RE: Sequoyah Fuels Corporation (SFC)
Preliminary Report
License SUB-1010

RE: Sequoyah Fuels Corporation
Preliminary Report Revisions
RCRA U3008(h) Administrative Order on Consent
EPA ID No. OKD051961183
Docket No. VI-0050(h)93-H

SFC Response to EPA Comments

Preliminary Report: Current Conditions and Investigations

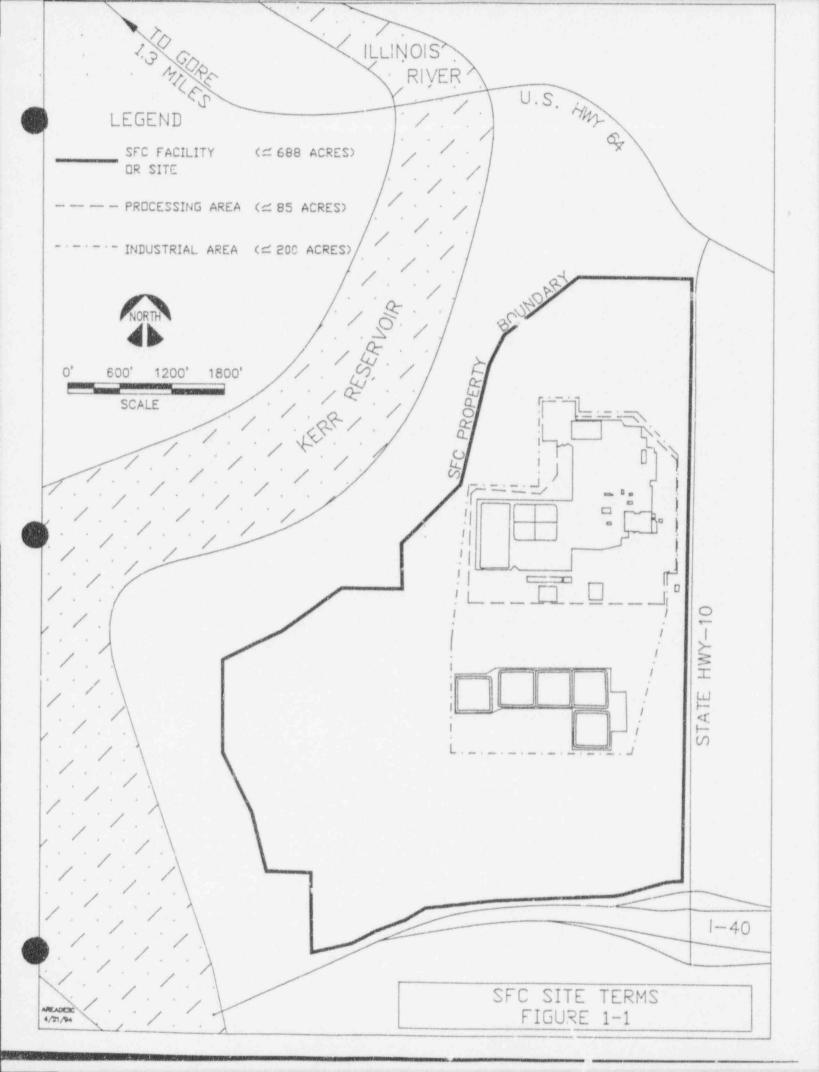
This section discusses characteristics of the facility, including the approximate area encompassed by the facility. Within this section, there are two references to area encompassed by the facility, specifically, 85 acres and 250 acres. These references are not consistent with the new section 1.6 added due to EPA's previous comment regarding facility terminology. SFC shall revise Section 2.1.2 to make it consistent with Section 1.6.

Response: SFC agrees with this comment and has made changes to clarify and provide consistency of terms. In addition to the requested changes, Section 2.1.1 and Figure 1-1 were also revised to be consistent with Section 1.6. Changes to the text are shown on pages 3 through 5 of Attachment 1 which correspond to pages 2-1, 2-2 and 4-19 of the report.
